Upper Peninsula Power Company

FERC Project No. 1864-164

Supplement to Request for Amendment: Docket P-1984-164

Re: Routing Analyses for Cisco Chain of Lakes Dam Outlet Alternatives

Exhibit 2 (b)
Cisco Lake Chain - Temporal Distribution of Outflows

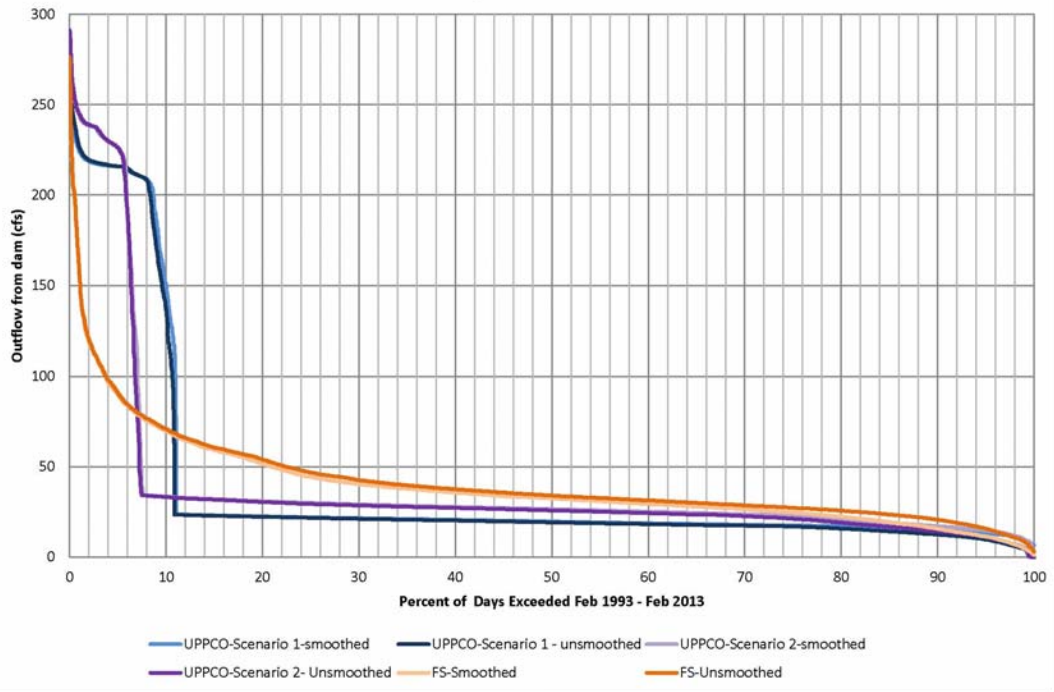
An action to reduce the average duration requires an adjustable spill area and increases the number of days with zero outflow. It also causes the figure in Exhibit 2(b) of **Appendix 4** to show "relative abrupt reductions in outflow" as described in Comment 1 of the Resource Agency Comment letter dated November 18, 2013 contained in **Appendix 5**².

The comment above focuses on the “relative abrupt reductions” and completely disregards the UPPCO design’s ability to provide “for downstream flow, or outflow from the reservoir” over 99% of the time as demonstrated in the hydrologic analysis or routing study of the UPPCO Proposal.

The hydrologic analysis or routing study also explains the magnification of the “relative abrupt reductions” in bullet point 3 of page 6 of the report as a simplification of the day-by-day and case-by-case decision process. In reality, the flow changes are only abrupt on a day to day basis and are made subject to the same restrictions currently outlined in the Operating Plan.

The “relative abrupt reductions” are also a function of the adjustable spill area that reduces the amount of time the reservoir is required to be above the maximum elevation as required in the Operating Plan (a requirement under Section 3.1.4.3 of the Settlement Agreement).

The comment compares the UPPCO proposal to the current USDA-Forest Service proposal that does not include the adjustable spill area. If the USDA-Forest Service Proposal incorporated an adjustable spill area, it too would show “relative abrupt reductions” in its routing study.
